PHILIPS MODEL EL3556A

PHILIPS *Service*

EL3556A/00/01

PHILIPS *Service* INFORMATION

Fig. 1.

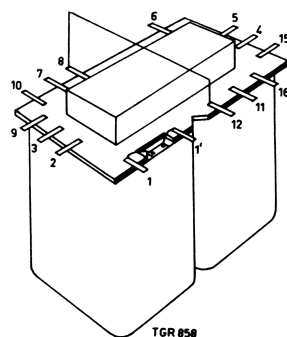
Starting with number WR01 the connections of transformer T1 have been changed. These are now as shown in Fig. 1.
Starting with number WR02, the recording-/playback head and its mounting have been changed.
When mounting a new head, mounting plate item 153 should also be replaced, see Fig. 2.

Code number new recording-/playback head : 4822 212 00957
Code number mounting plate : 4822 212 00959
Code number of Re1 : 4822 212 00816
Code number of Re2 : 4822 212 00655

Fig. 1

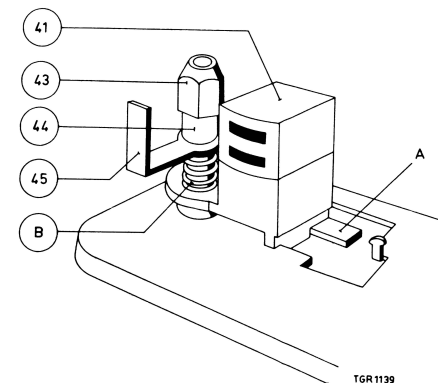
In view of standardisation, a new erase head and new tape guides have been applied in these recorders from marking WR03 onwards. These parts cannot be interchanged with those of apparatuses with a marking before WR03.

Adjusting the new erase head, see Fig. 1

The new erase head can be adjusted by bending lug A up or down. The erase head is adjusted till the top of the core of the upper coil is flush with the top of the tape, see Fig. 2.

Fig. 1

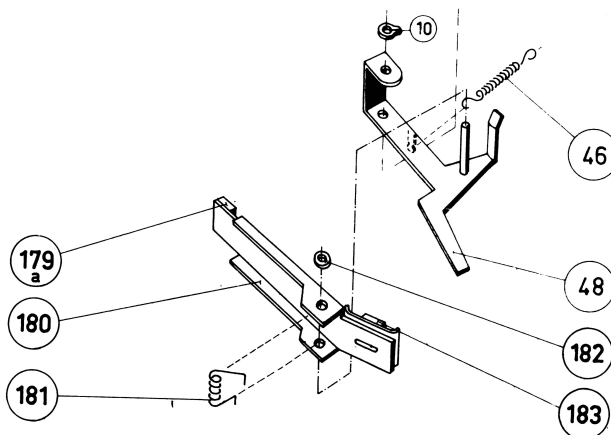
As from stamp WR04 10/66 the erase head is equipped with a pressure felt, to prevent looping. In view of this pressure bracket, item 48, has been completely modified so, that a bracket as shown in Fig. 1 is obtained. This construction (items 180 + 48) can also be applied in apparatuses previous to WR04 10/66.

Code number bracket item 48	4822 403 20015
Code number bracket item 180	4822 403 40025
Code number pressure felt item 183	4822 212 00861
Code number spring item 181	4822 492 40234
Code number pressure felt item 179a	WY 820 38
Code number clamping ring item 182	4822 175 01168
